Mobile Intel® Pentium® 4 Processor-M

Specification Update

October 2005

Document Number: 250721-031

Figure 13. System Bus Reset and Configuration Timings

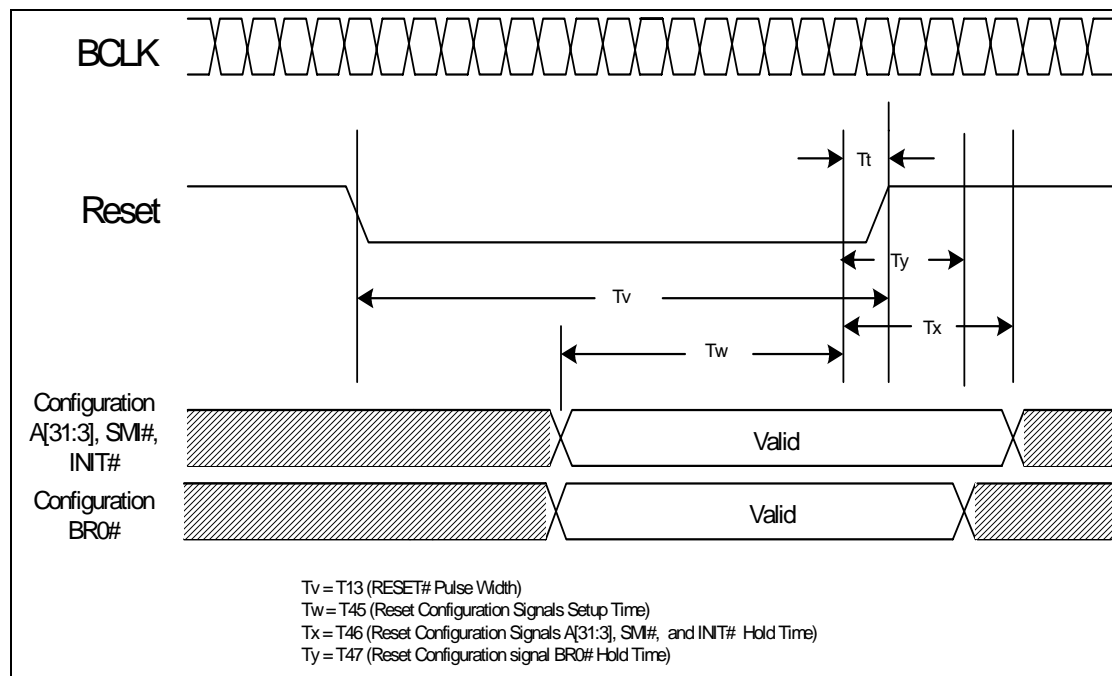
T2. BR0# Maximum Hold Time Specification Change

The BR0# maximum hold time has changed to 2 BCLKs. This change will be shown in the “System Bus AC Specifications (Reset Conditions)” table and “System Bus Reset and Configuration Timings” figure of the *Mobile Intel® Pentium® 4 Processor - M Datasheet*. This change will be incorporated in the next revision of the datasheet.

The following figure will be modified to reflect this change:

T# Parameter	Min	Max	Unit	Figure	Notes
T45: Reset Configuration Signals (A[31:3]#, BR0# INIT#, SMI#) Setup Time	4		BCLKs	13	1
T46: Reset Configuration Signals (A[31:3]#, INIT#, SMI#) Hold Time	2	20	BCLKs	13	2
T47: Reset Configuration Signal BR0# Hold Time	2	2	BCLKs	13	2
